BHP Pilbara Strategic Assessment

**Jimblebar Significant
Amendment**

Validation Notice

31 January 2025

SCALE @ A4: 1:125,000	PREPARED: SPATIAL DATA	FIGURE: 1-2
DATE: 3/04/2024	REQUESTOR: ENV. APPROVALS	NO: 1021/145B

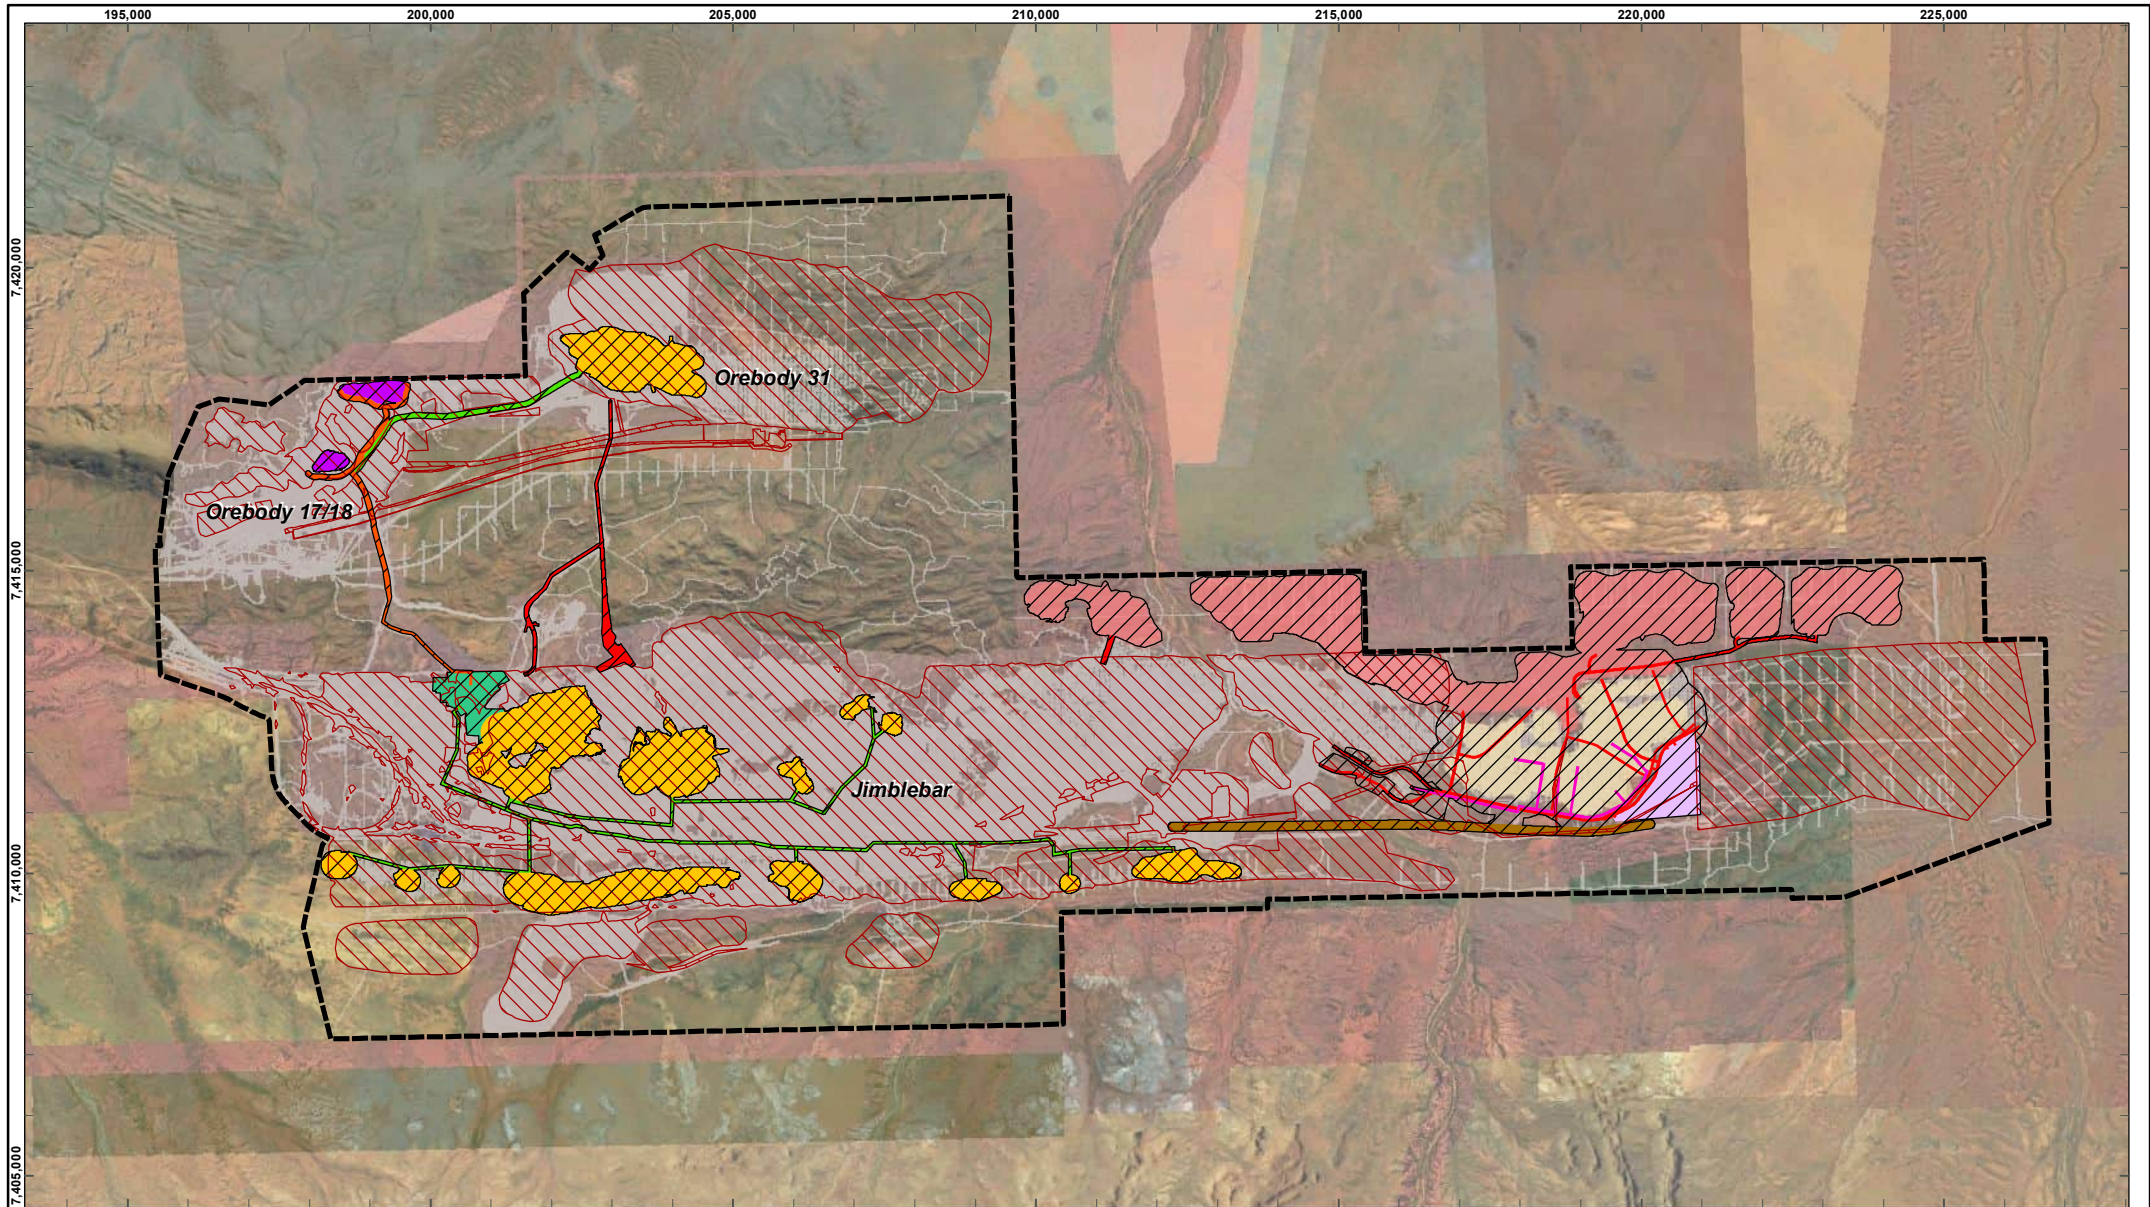
1.4.2	1.4.2 In Figure 1.2 (p.6), the Indicative Footprint should include the proposed location of the project elements of the Activity listed in Section 1.4, such as proposed pits and OSAs and infrastructure such as haul roads and the overland conveyer, to assist the reader to identify potential impacts to Program Matters.	This comment is a repeat of a previous comment. Figure amended.

2.2	Project Disturbance and Description (p. 12) states that Figure 1-2 illustrates the location of the proposed works comprising the Activity. As mentioned in the Introduction section, this figure only shows the Indicative Footprint as shaded areas and does not illustrate the proposed location of the project elements of the Activity.	This comment is a repeat of a previous comment. Figure amended.

1.4.2 Figure 1.2 <i>Activity Area and Indicative Footprint</i> – Please confirm whether the 'Previously Assessed Areas' within the Activity Area reflect area assessed only in relation to the EPBC Act such as approvals under Part 9 or previous validation notices.	Previously assessed areas have been assessed under the existing Validation Notices in place for Jimblebar and under previous Ministerial Statements.

SCALE @ A4: 1:120,000 PREPARED: SPATIAL DATA FIGURE: 5-1
 DATE: 7/08/2024 REQUESTOR: ENV. APPROVALS NO: 1021/173B

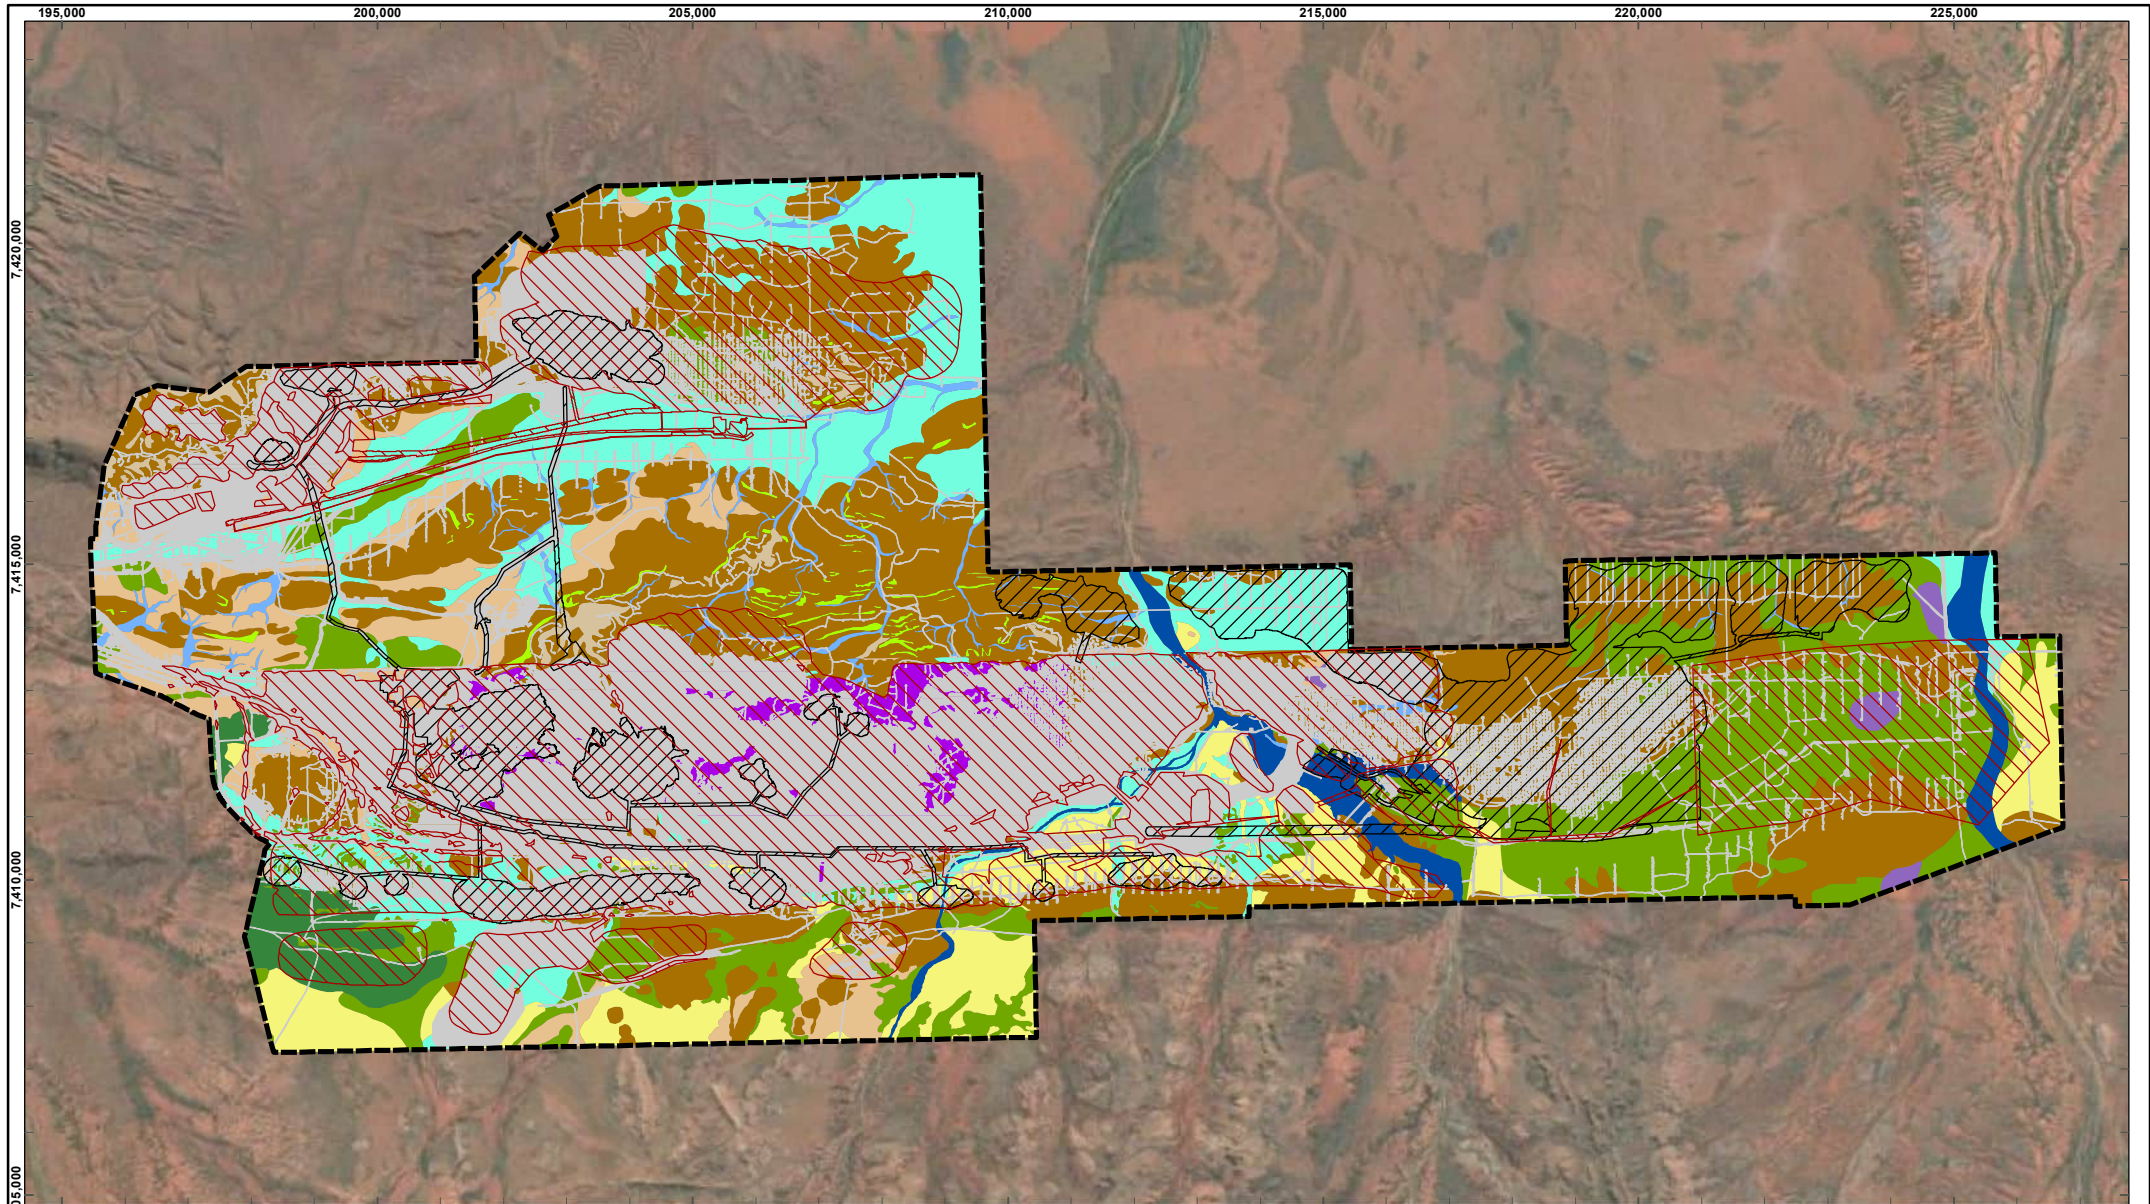
5.1.5 Figure 5-1 <i>Vertebrate Fauna Habitat</i> – we recommend also depicting the ‘previously assessed areas’ (not yet cleared) on this figure.	Figure has been updated.

5.1.5 Unintentional error: Figure 5-1 <i>Vertebrate Fauna Habitat</i> - please amend Proposed Development Envelope to Activity Area.	Updated.
5.2 Northern Quoll	5.2.1 Figure 5-2 <i>Northern Quoll regional records and distribution</i> includes Northern Quoll records after 2005. The <i>EPBC Act Strategic Environmental Assessment Five Year Review 9 May 2023</i> states that since 2017, there have been 1133 new records of Northern Quoll within the SAA (only 21 of which have been detected by BHP). Are these records reflected in the figure? If not, we suggest indicating the figure shows Northern Quoll records between 2005-2017.	Figure has been updated.

Scale @ A4: 1:3,500,000	Prepared: SPATIAL DATA	Project No: A1021/152
Date: 9/08/2024	Checked:	Figure: 5.7
Revision: REV B	Reviewed: ENVAPPROVALS

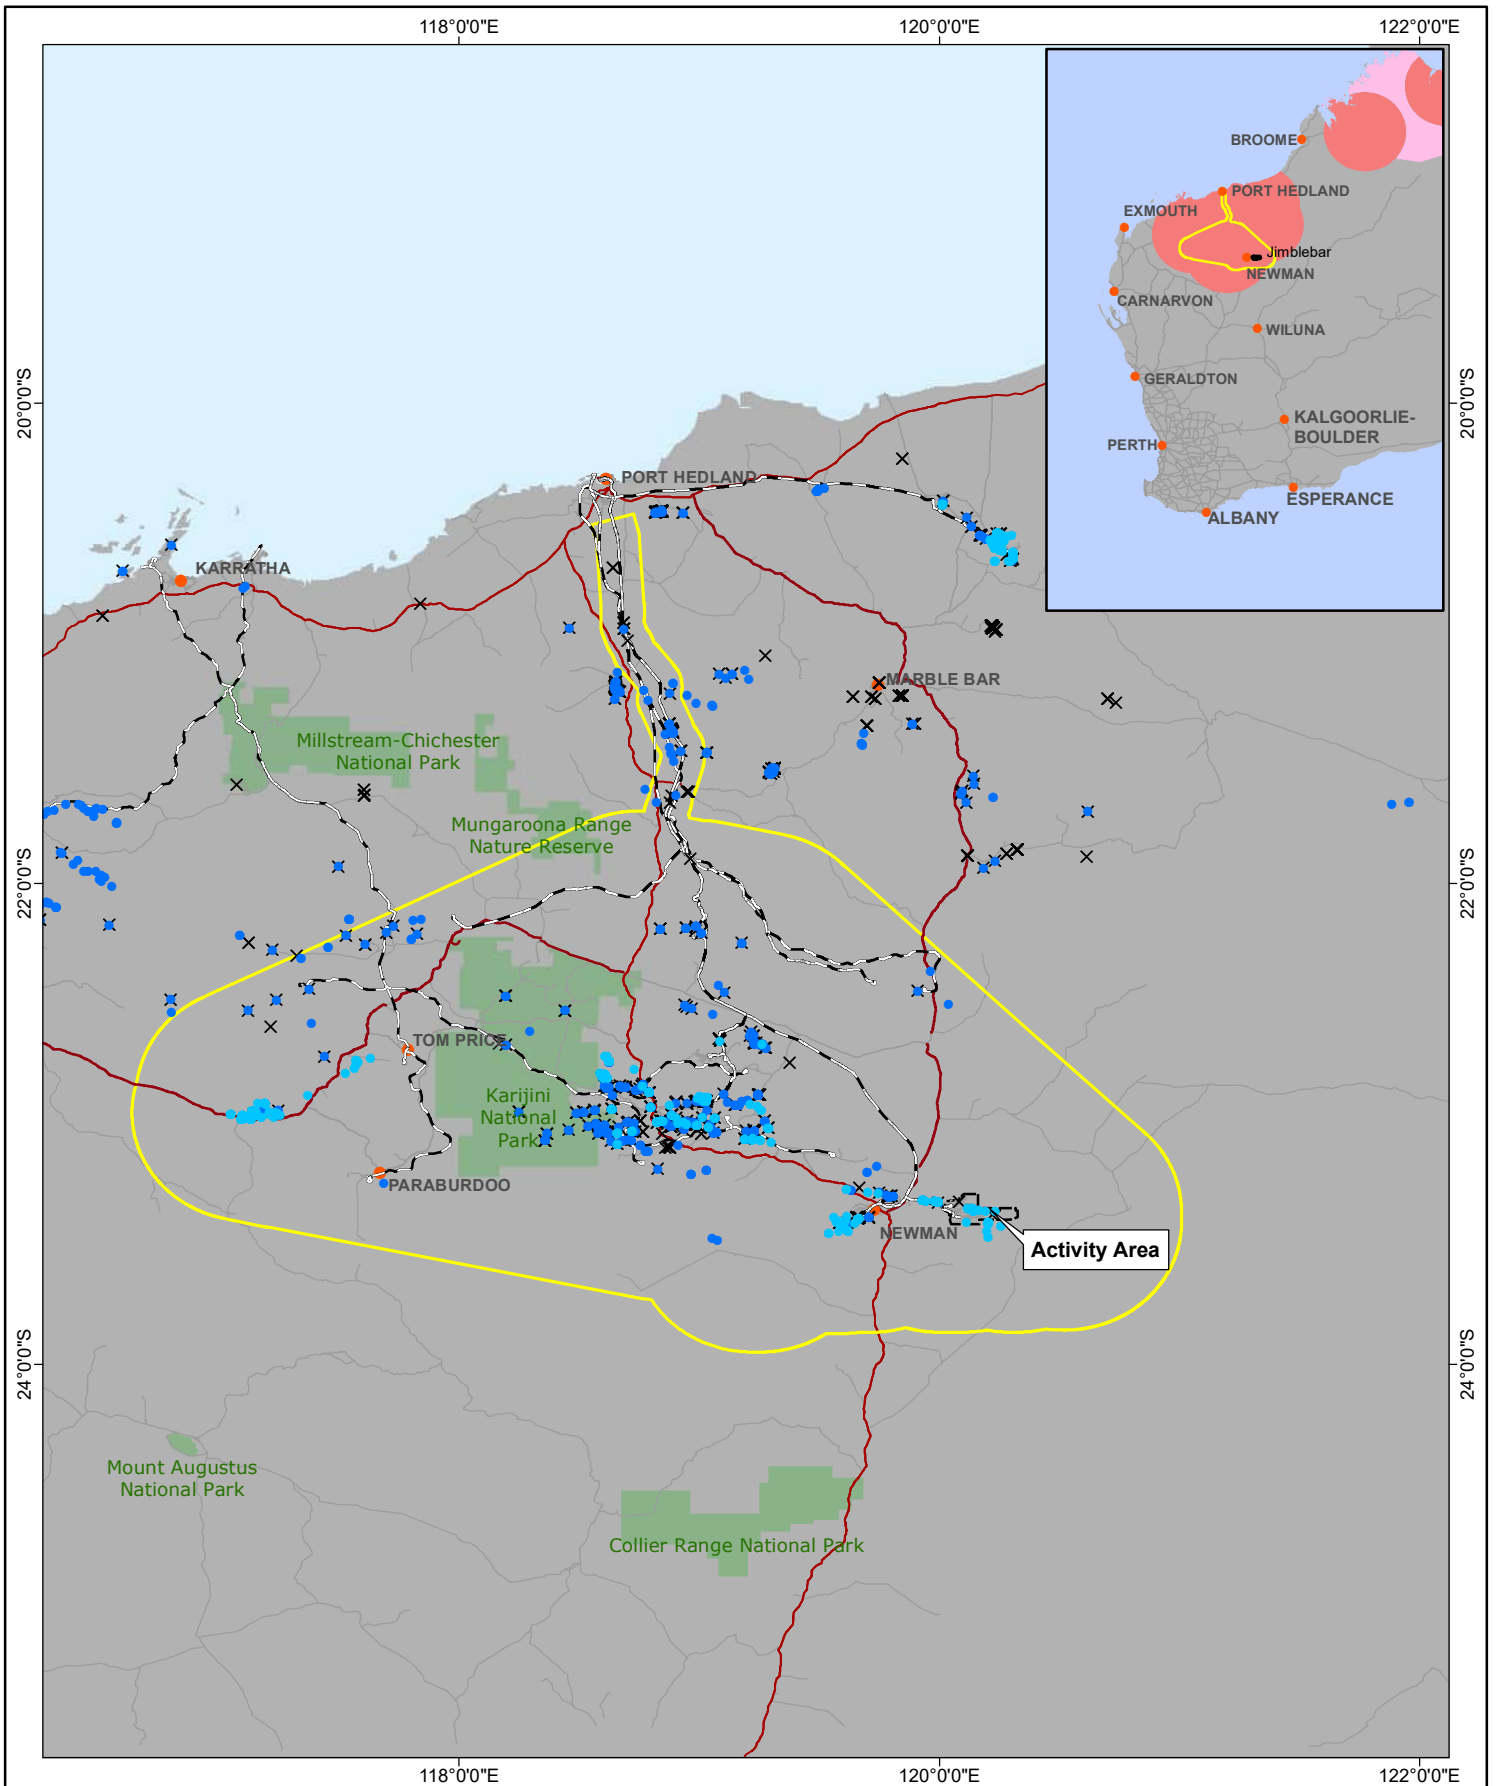
5.3 Ghost Bat	5.3.1 Figure 5-7 Ghost Bat <i>Regional records and distribution</i> (dated 02/02/2024) includes Ghost Bat records after 2005. The <i>EPBC Act Strategic Environmental Assessment Five Year Review 9 May 2023</i> states that since 2017, there have been 1067 new records of Ghost Bat within the SAA (with	Figure updated.

Section	DCCEEW comment	BHP response
	796 having been detected by BHP). Are these records reflected in the Figure 5-7? If not, we suggest indicating the figure shows Ghost Bat records between 2005-2017.

5.3 Ghost Bat	5.3.3.1 Inadvertent error: <i>Local Habitat</i> (p. 48) states that the Activity Area falls within the current distribution of Ghost Bat whereby the species or species habitat ' <i>may occur</i> '. Figure 5-7 indicates that Ghost Bat are ' <i>likely to occur</i> '. Please amend if appropriate.	Updated.
